FIELD CHANGE ORDER

Reference No. : FCO74200006
Date : July 2002
Product Group : 742

Transport wheel problems with generator cabinet 40E.

Illustration 1

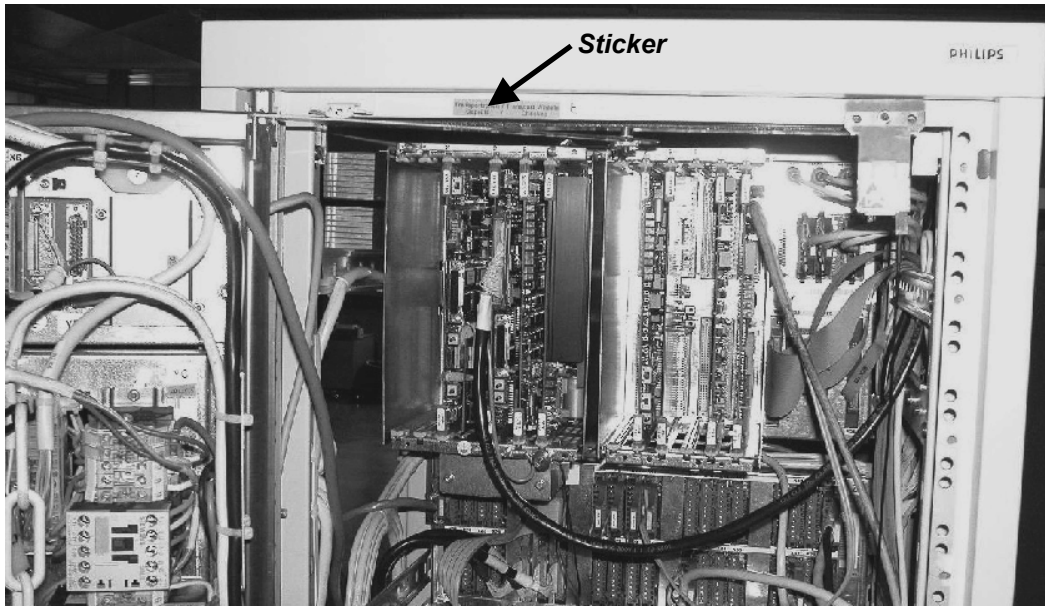
- Check for sticker '**Transport Wheels Checked**' at the upper left corner of the cabinet (illustration 1).

- Stick the sticker at the upper left corner of the cabinet (illustration 1 on page 3).

Illustration 3

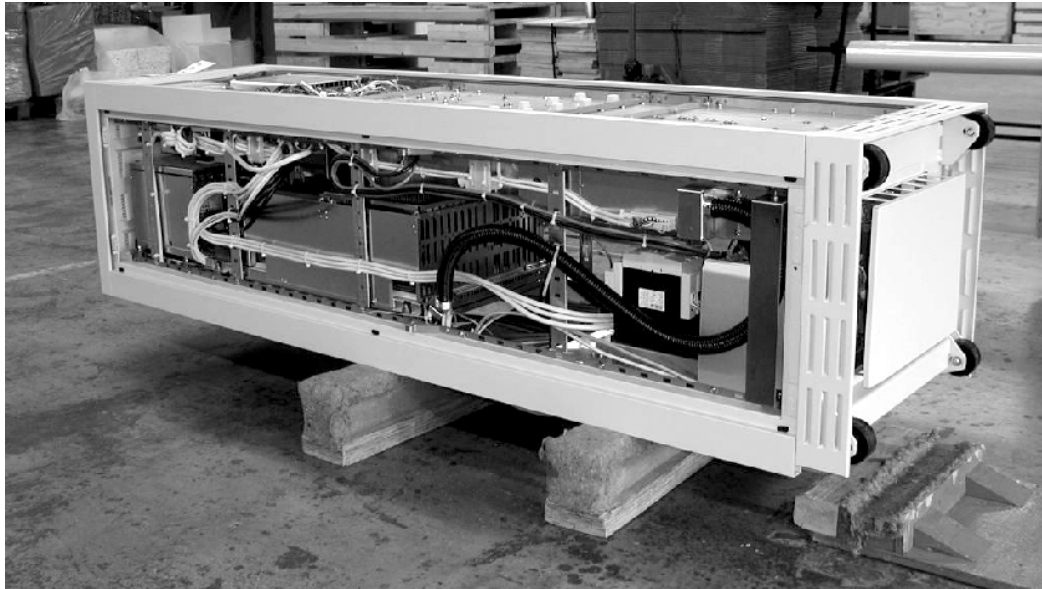
- In case of SCP or Optimus CP without Grid Switch tilt the generator through 90° and place it upon suitable wooden bars (illustration 3). For this work two persons are required.
- In case of Grid Switch the GS tank must be removed before the generator is tilted.
- In case of Optimus Rad / RF / C the tank must be removed before the generator is tilted.

Illustration 4

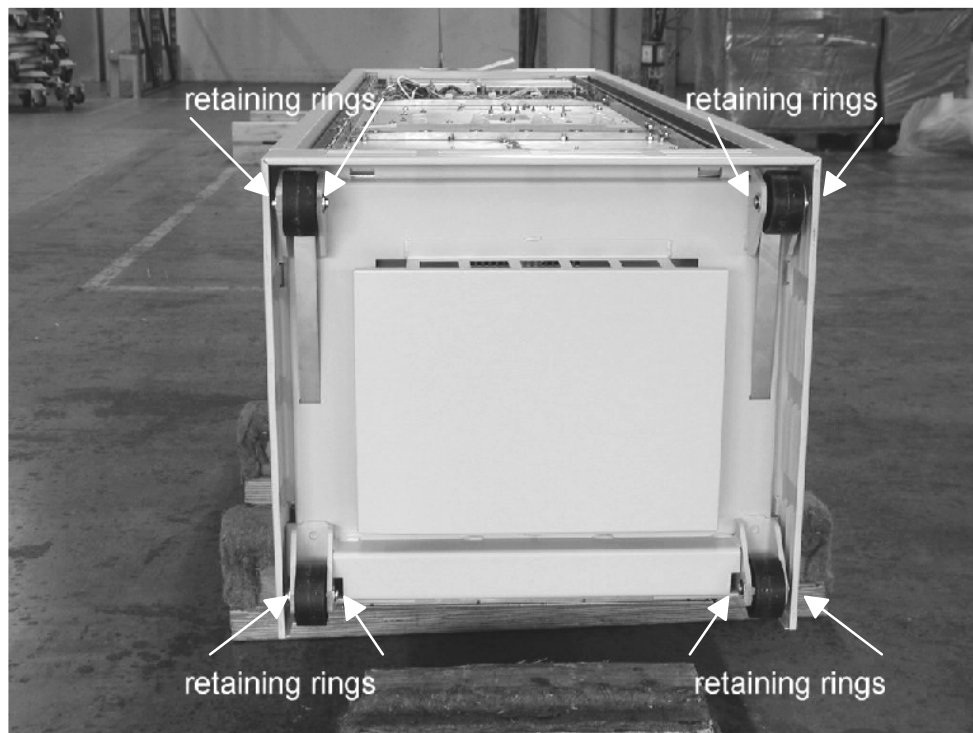
- Check of all four transport wheels (illustration 4).
The four transport wheels are secured with retaining rings on the axles.
The retaining rings are located on the left-hand and right-hand side of each axle (8 pieces).
